## **CASHLESS TOLLING**

**TA 19-1, Contract No. D800002**

**Addendum #5**

**April 11, 2019**

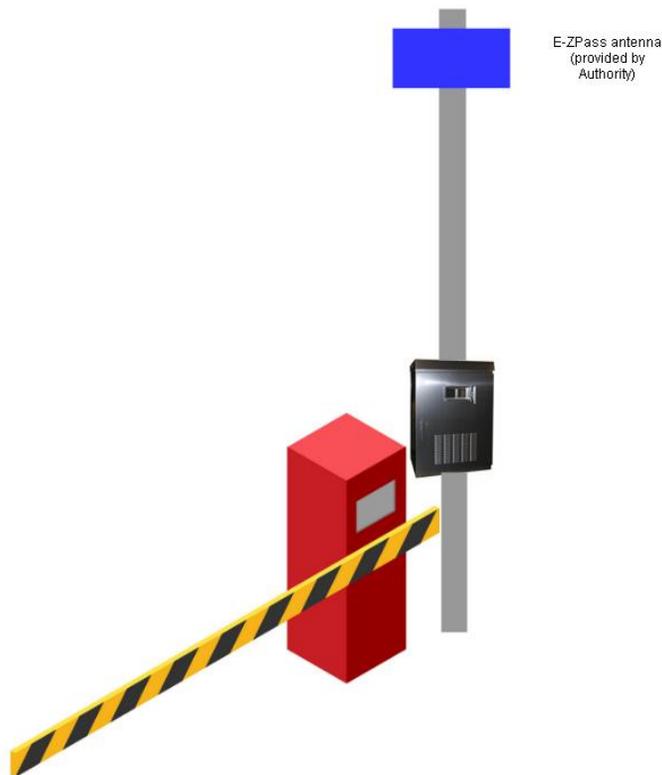
The Design-Builder shall provide an equipment cabinet as specified in 680.8020XX25 Cabinets for ITS Equipment. The cabinet provided shall be the one specified for TRANSMIT. The Equipment Cabinet shall be mounted on a 20 foot tall pole, per the following specifications: 670.1120 (20' tall light pole), and 670.0106 (6' pole foundation)

The cabinet shall be mounted on the pole at a height of 3 feet. The cabinet shall be adjacent to the BGS.
